EDWIN I. HATCH NUCLEAR PLANT, UNIT NO. 2

AMENDMENT TO FACILITY OPERATING LICENSE

Amendment No. 28
License No. NPF-5

SAFETY EVALUATION BY THE OFFICE OF NUCLEAR REACTOR REGULATION
SUPPORTING AMENDMENT NO. 28 TO FACILITY OPERATING LICENSE NO. NPF-5

FIGURE 3.2.1-5

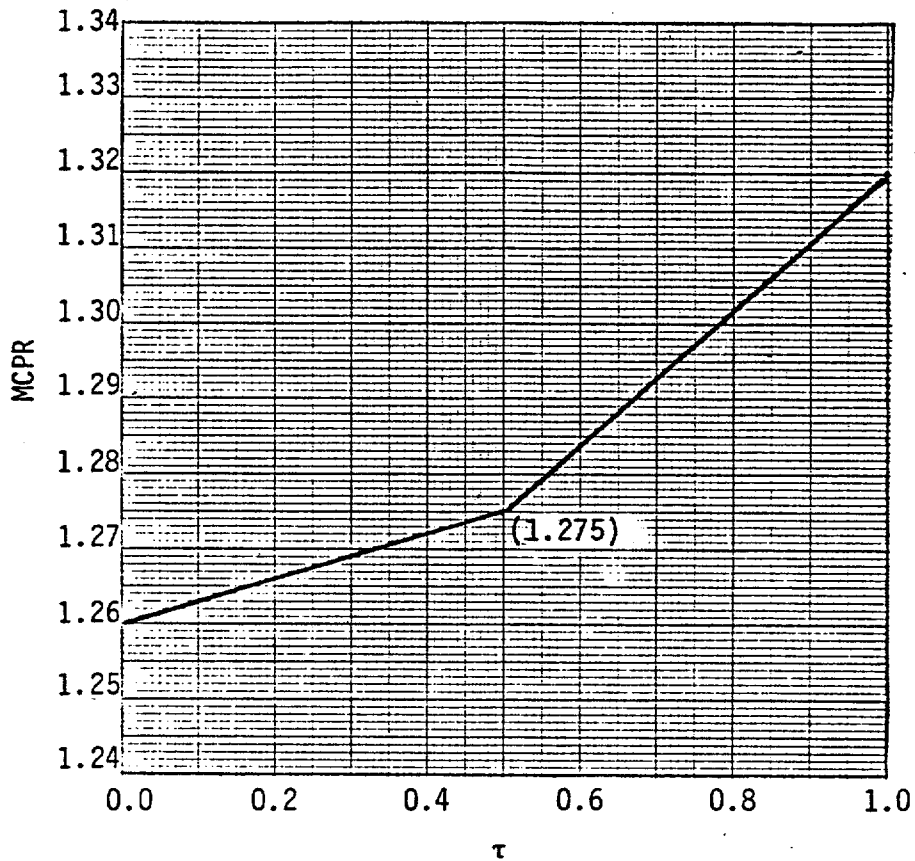
This reload involves loading of prepressurized GE 8x8 retrofit (P8x8R) fuel. This is the same type of fuel as was loaded during the previous reload. The description of the nuclear and mechanical designs of 8x8 retrofit is contained in References 3 and 4. Reference 3 also contains a complete set of references of topical reports which describe GE's analytical methods for nuclear, thermal-hydraulic, transient and accident calculations, and information regarding the applicability of these methods to cores containing a mixture of fuel. The use and safety implications of prepressurized fuel have been found acceptable per Reference 4. The conclusions of Reference 5 found that the methods of Reference 3 were generally applicable to prepressurized fuel. Therefore, unless otherwise specified, Reference 3, as supported by Reference 5, is adequate justification for the current application of prepressurized fuel.

3.2.1 All AVERAGE PLANAR LINEAR HEAT GENERATION RATES (APLHGRs) for each type of fuel as a function of AVERAGE PLANAR EXPOSURE shall not exceed the limits shown in Figures 3.2.1-1, 3.2.1-2, 3.2.1-3, 3.2.1-4, or 3.2.1-5.

MCPR LIMIT FOR P8X8R FUEL AT RATED FLOW
FIGURE 3.2.3-2

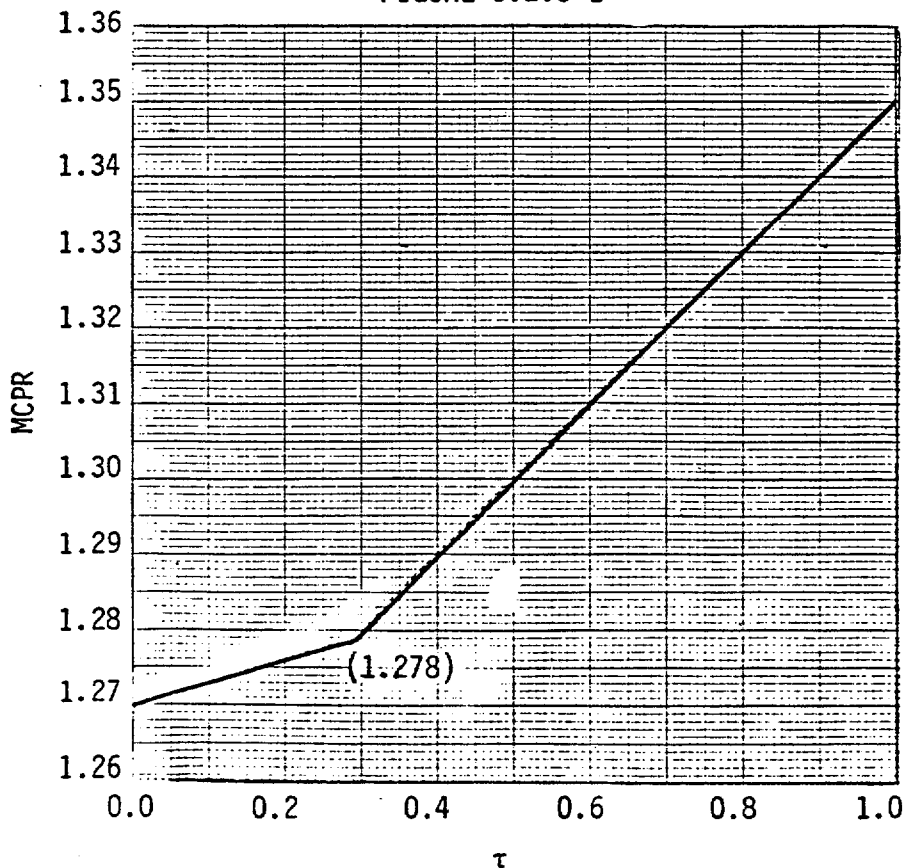
The reload application follows the procedure described in NEDE-24011-P-A-2, "Generic Reload Fuel Application". We have reviewed this application and the consequent TS changes. The transient analysis input parameters are typical for BWRs and are acceptable. Core wide transient analysis results are given for the limiting transients, and the required operating limit values for minimum critical power ratio (MCPR) are given for each fuel type. The revised MCPR limits are required by the reload, and they are acceptable.

To assure that the fuel cladding integrity SLMCPR will not be violated during any abnormal operational transient or fuel misloading, the most limiting events have been reanalyzed for this reload by the licensee in order to determine which event results in the largest reduction in the MCPR. These events have been analyzed for the exposed fuel and fresh fuel. Addition of the largest reductions in critical power ratio to the SLMCPR was used in the MCPR TS to establish the operating limits for each fuel type.

We have found the methods used for this analysis consistent with previously approved past practice (Ref. 3). We have found the results of this analysis and the corresponding TS changes acceptable.
